Architect's Supplemental Instructions

Architect's ASI No: 017

Project:
Webster University
Interdisciplinary Science
Building

Date Issued: 10/17/2016

SHEET E0103.A LEVEL 03 AREA A FLOOR PLAN – ELECTRICAL & AUXILIARY

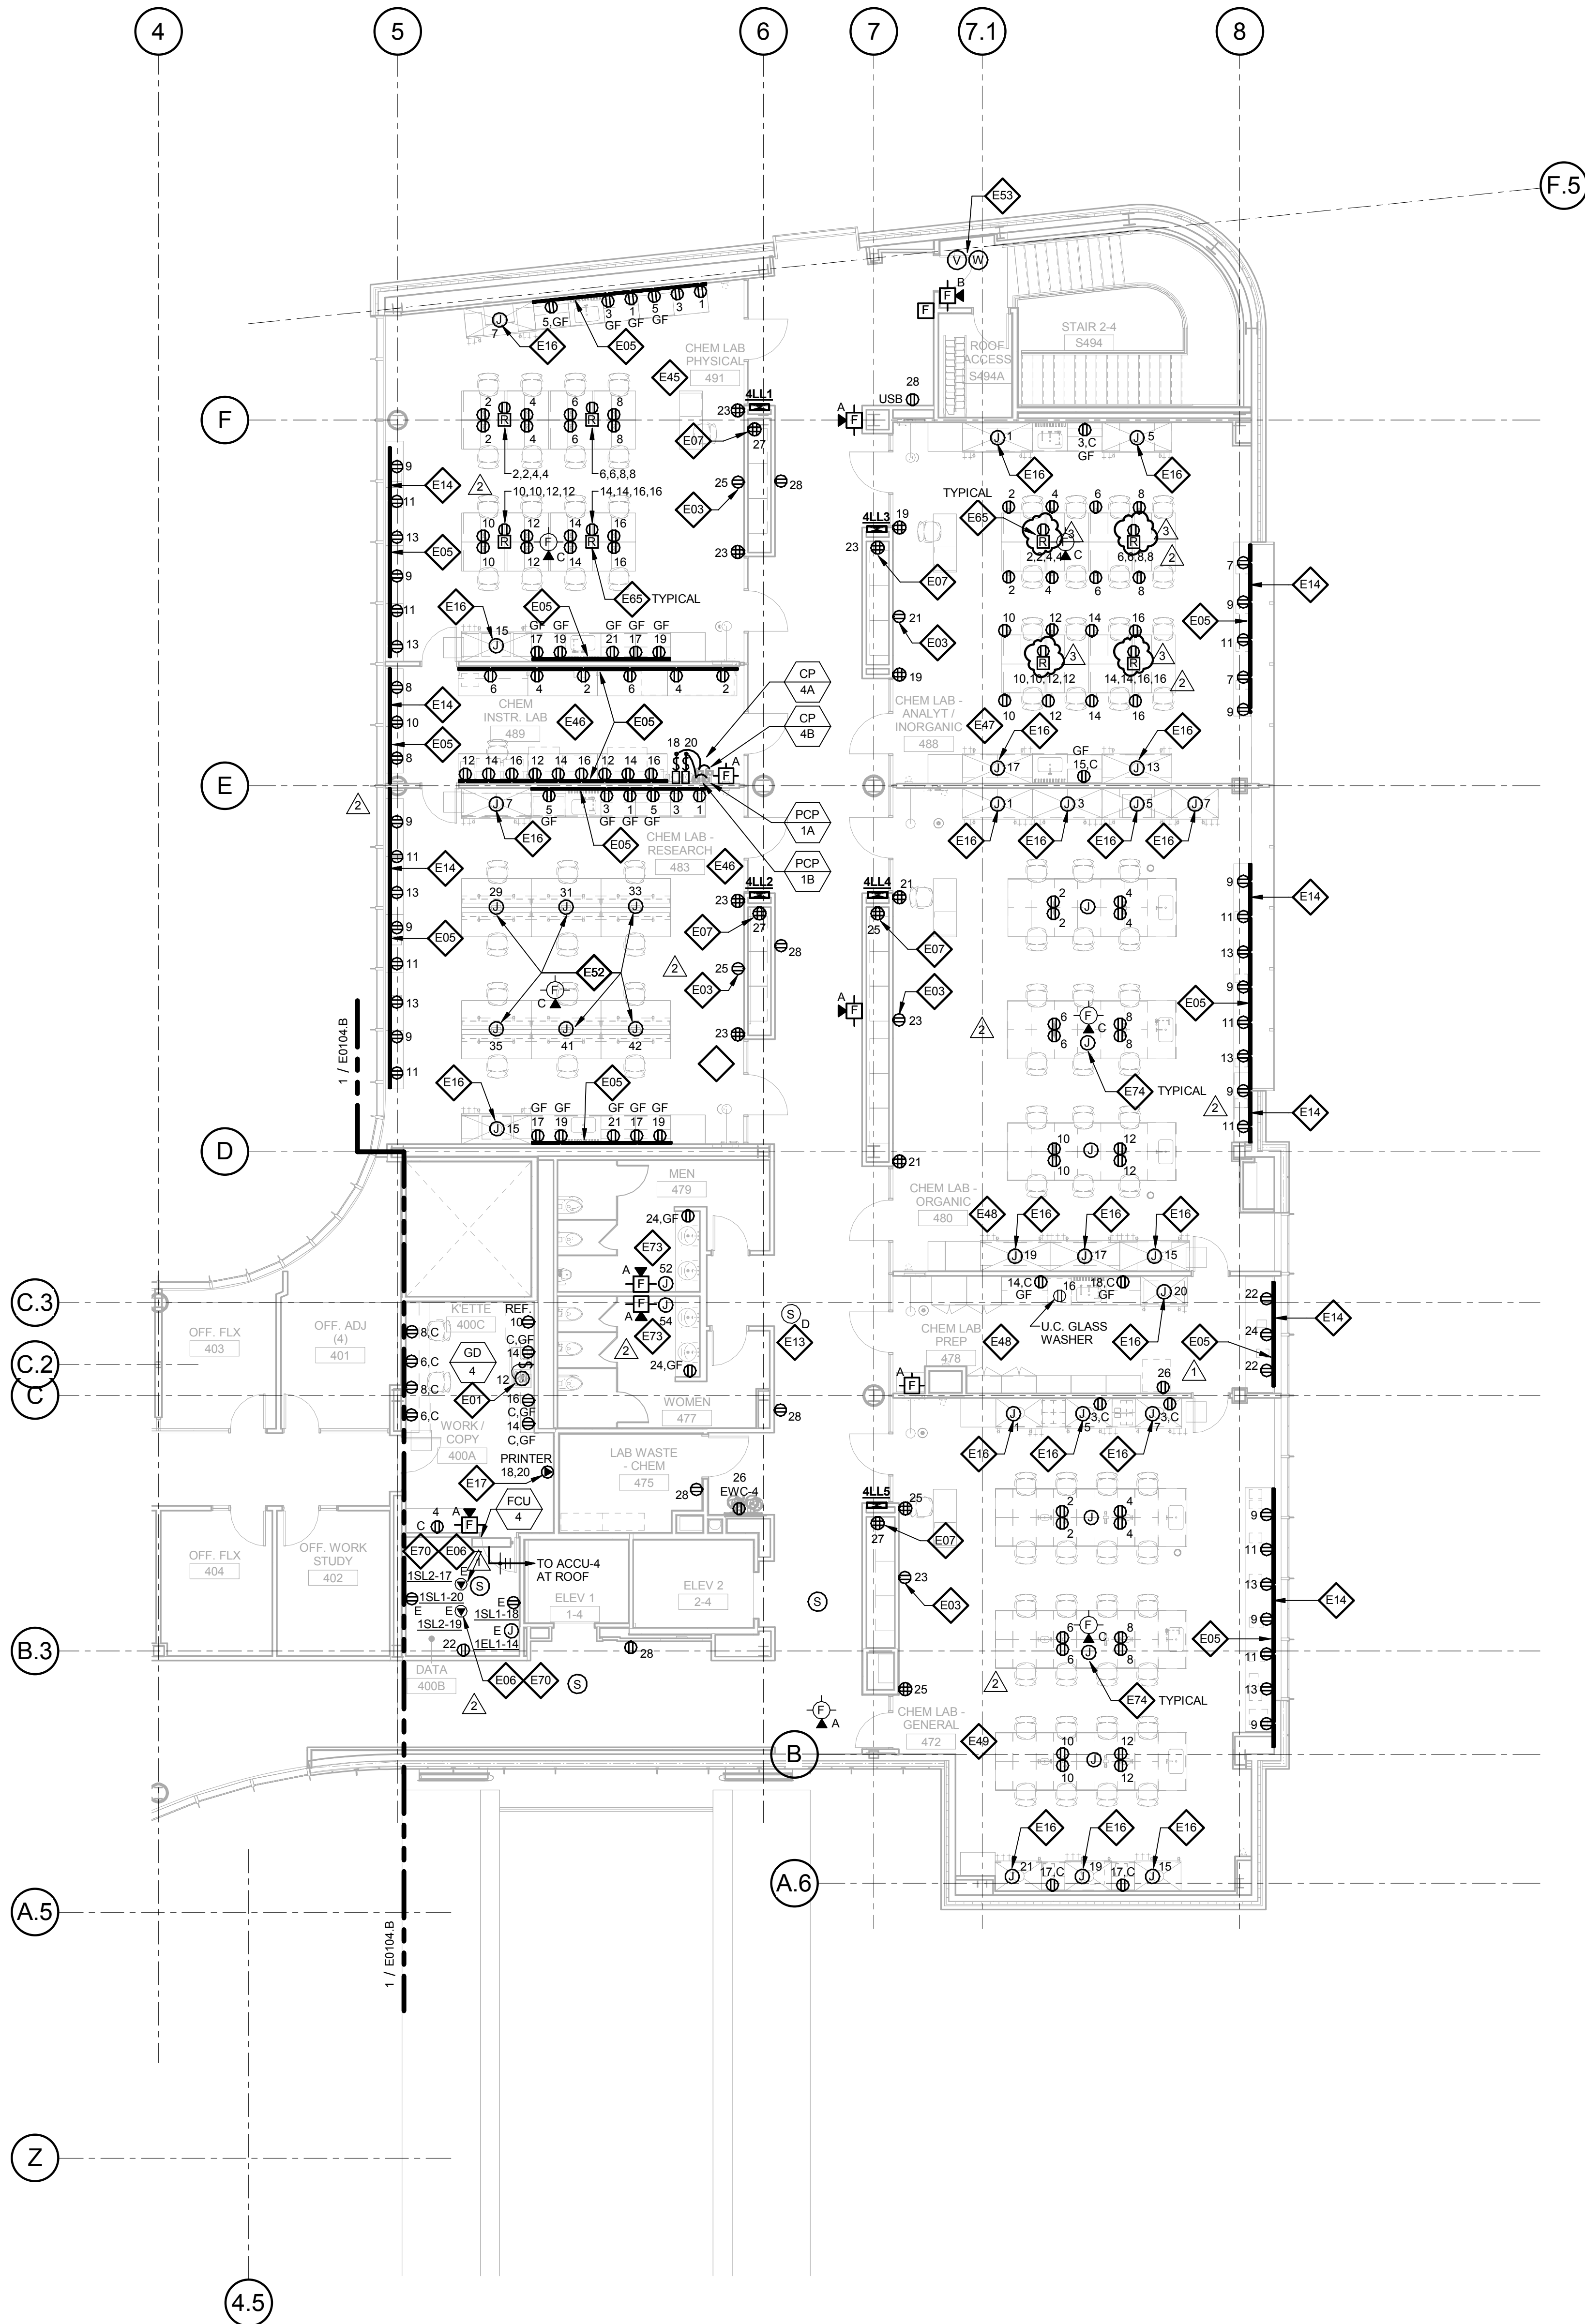
- Revise Keyed Note E62 to replace, “20A TWIST-LOCK RECEPTACLES, NEMA L5-20R” with “20A STANDARD DUPLEX RECEPTACLES, NEMA 5-20R”.
- Revise associated floor box symbols to indicate a standard duplex receptacle in-lieu of a special receptacle.

12 TABLE WITH ELEC. OUTLETS ON APRON
3/4" = 1'-0"

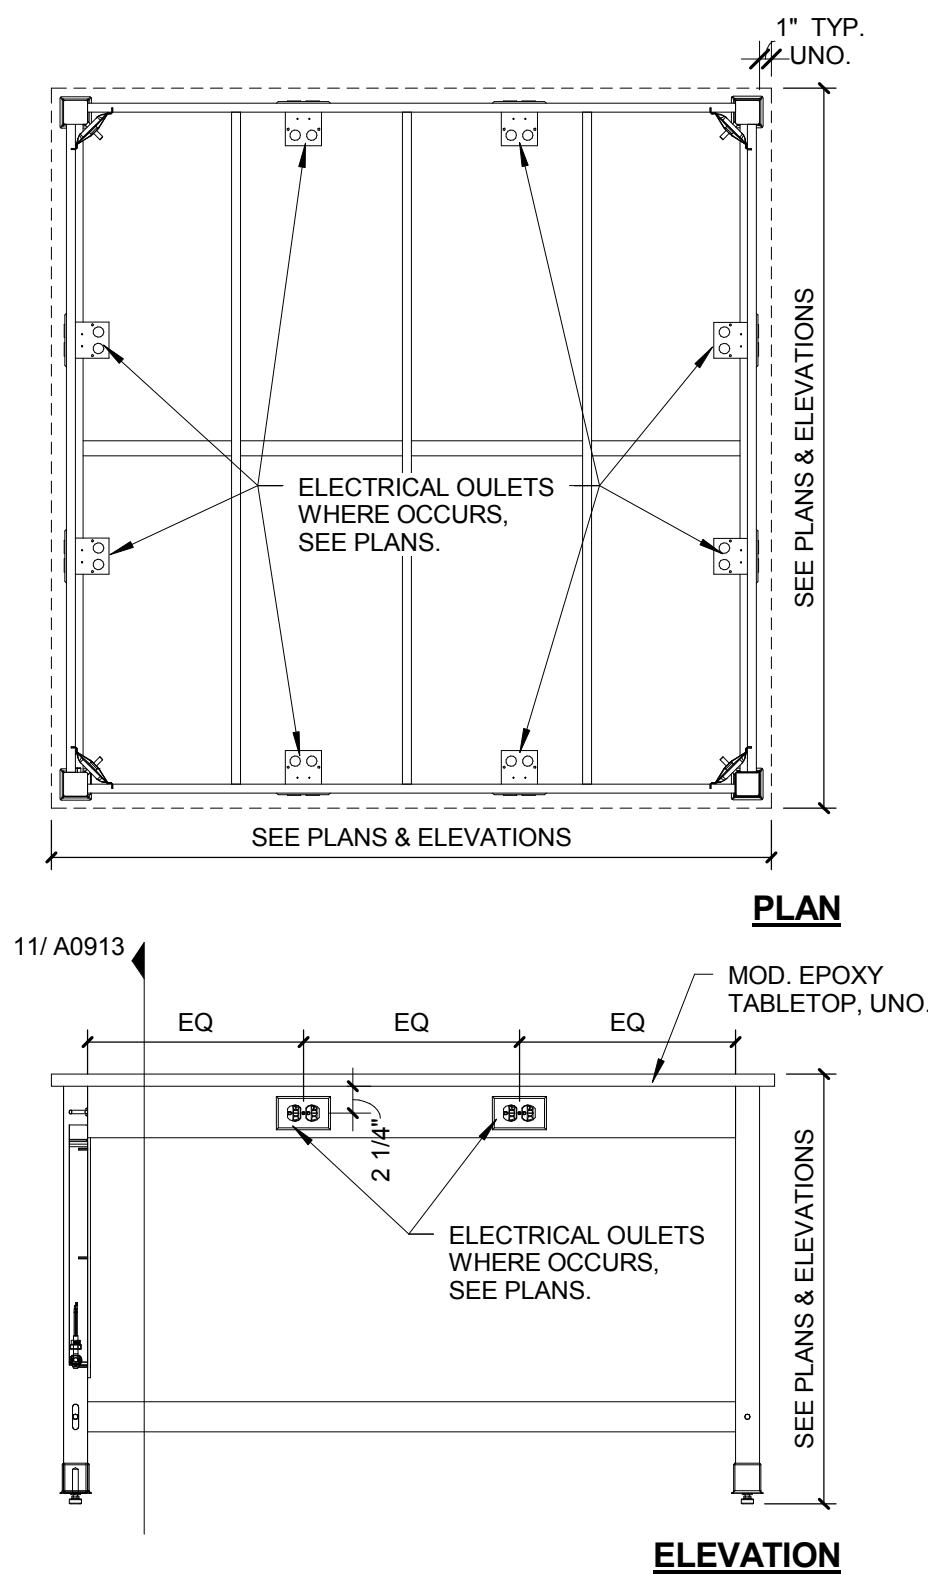
- Revised lab table's 6' power chord whip to have standard electrical plug instead of twist lock plug. Related note revised on details – 3,11,12/A0913.
